IDAHO DEPARTMENT OF WATER RESOURCES
RECOMMENDATION OF WATER RIGHTS ACQUIRED UNDER STATE LAW

RIGHT NUMBER: 63-9588

Post-review follow up issues for IDL claims in basins 61 and 63.

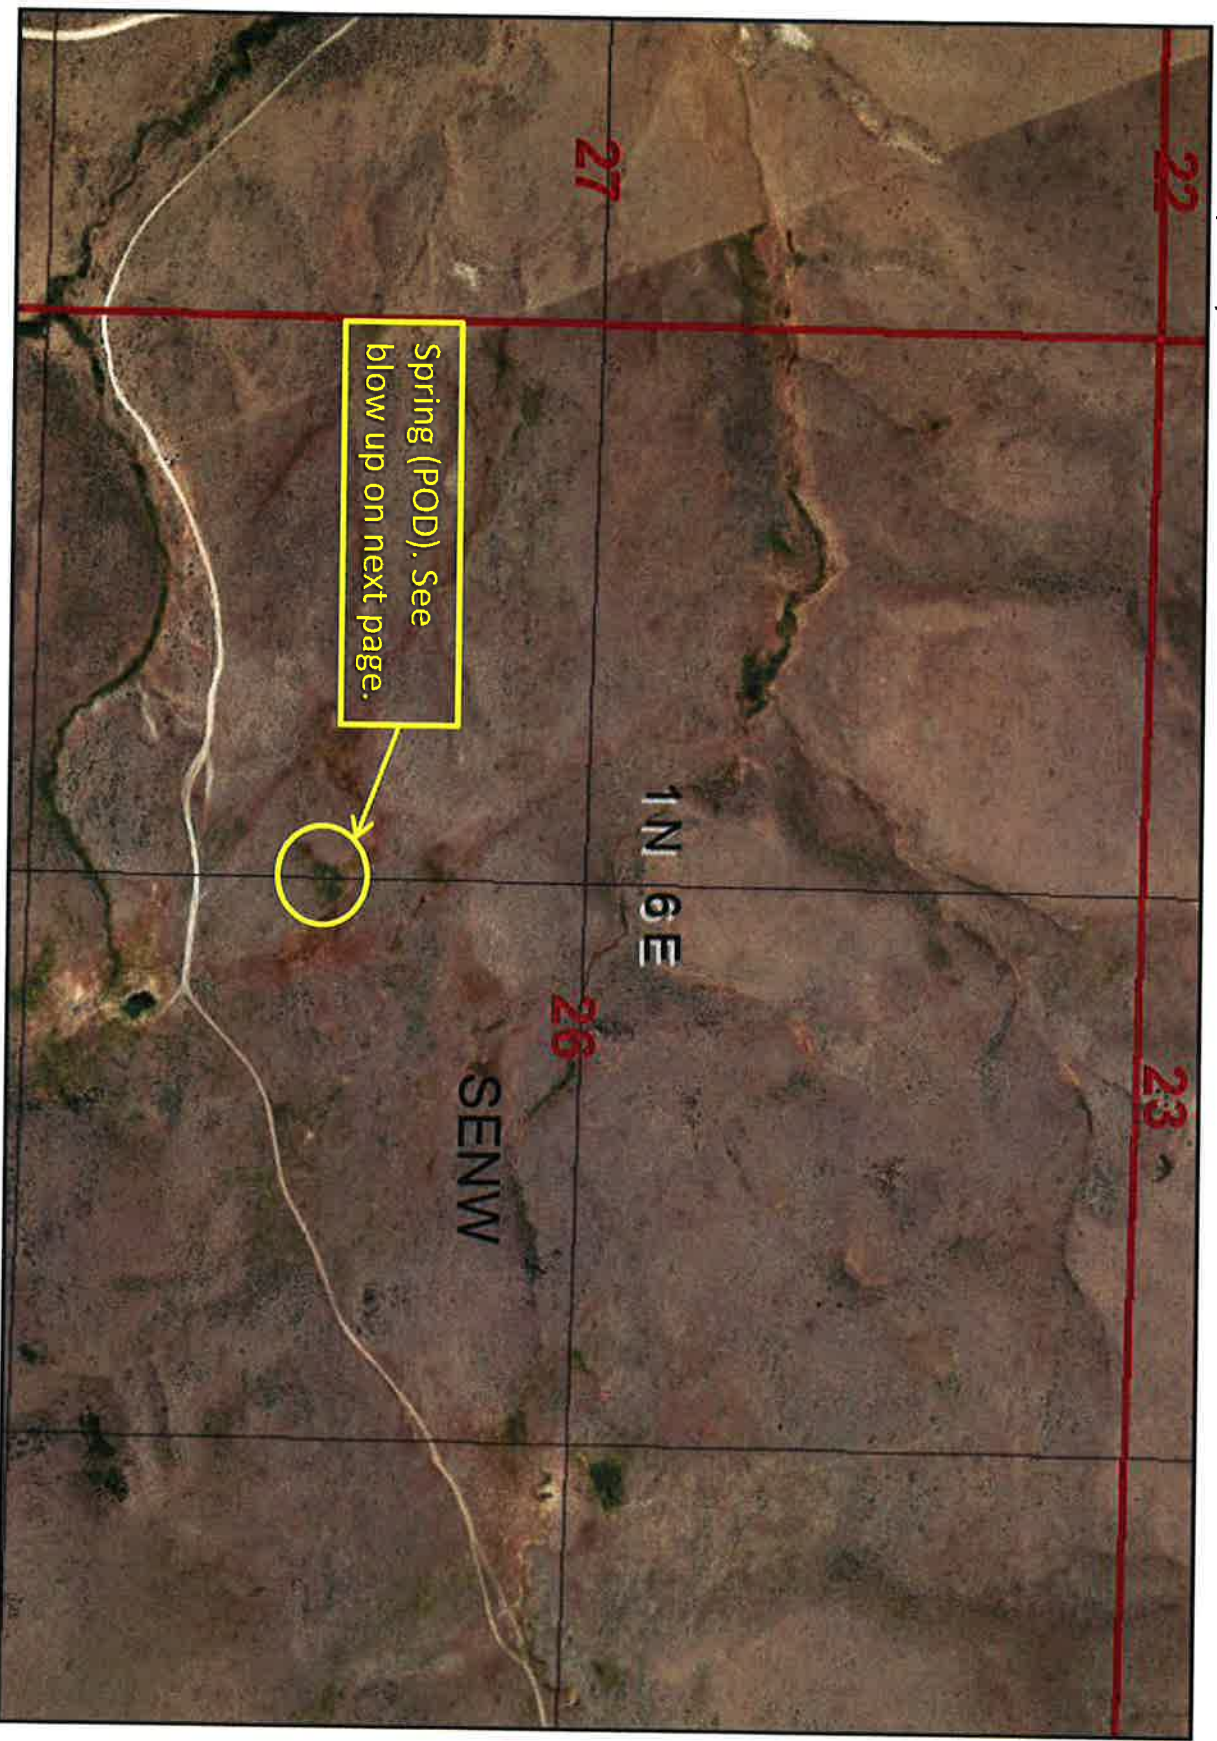
63-9587	IDL believes the head box has always been in Sec. 24 NWSW, and the original claim location in SWNW is a mapping error
* 63-9588	There are 4 small ponds along a stream channel north of the road *
63-9590	Water system consists of four stock tanks south of the road
63-9590	Consists of a collater system at spring sources south of the road
63-9591	
63-9591	The head box is located in the fenced enclosure
63-9804	Water system consist of two stock tanks in Sec. 11, SE5W; IDL did not find any other tanks in Sec. 14
63-9804	IDL did not find any other head boxes in Sec. 14

63-09588

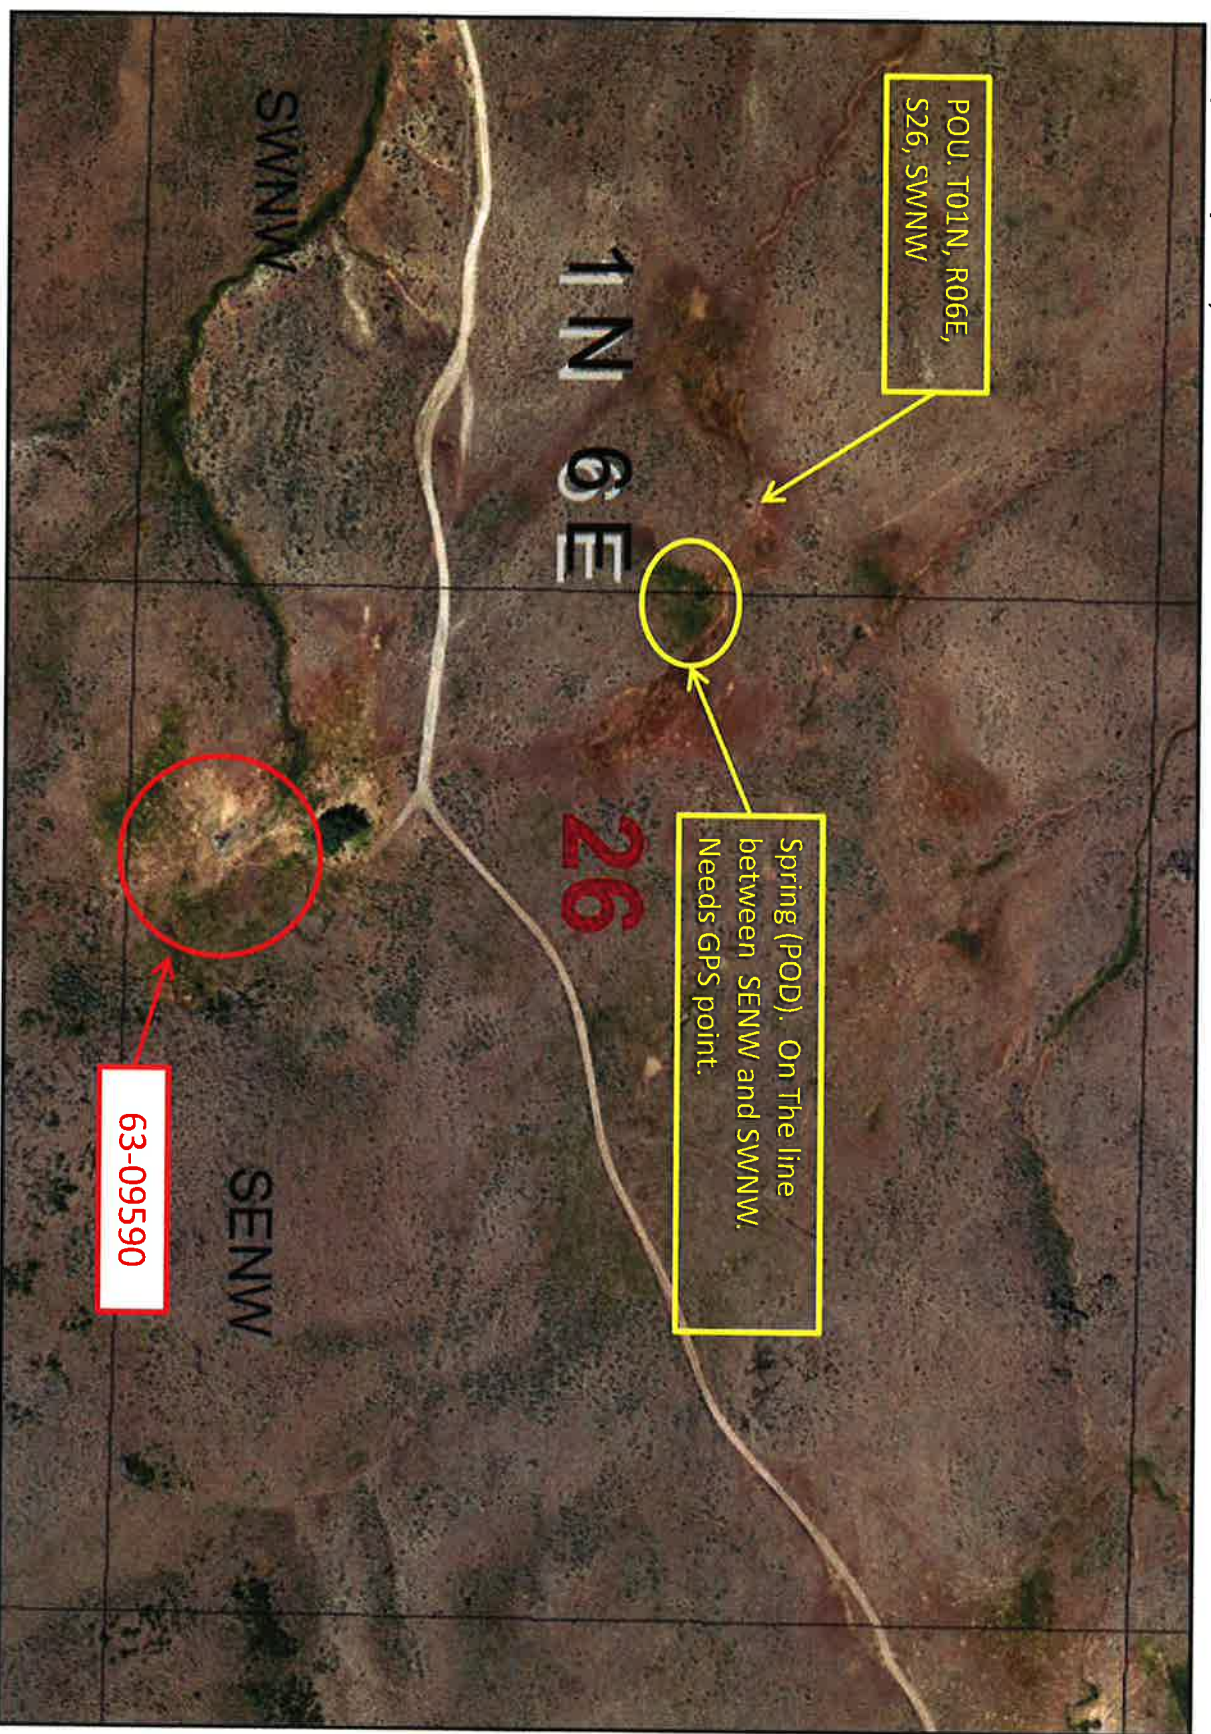
The POD is located on the line between the SENW and SWNW quarter-quarters. A GPS reading would be needed to determine exact location of the POD. Also, aerial photography shows the POU located in T01N, R06E, S26, SWNW instead of T01N, R06E, S26, SENW.

POU is not clearly given by
the GPS point or from IDL.

I will include the string of ponds
shown in the aeriols, downstream
from the GPS point/POD.

Not this site-per IDL
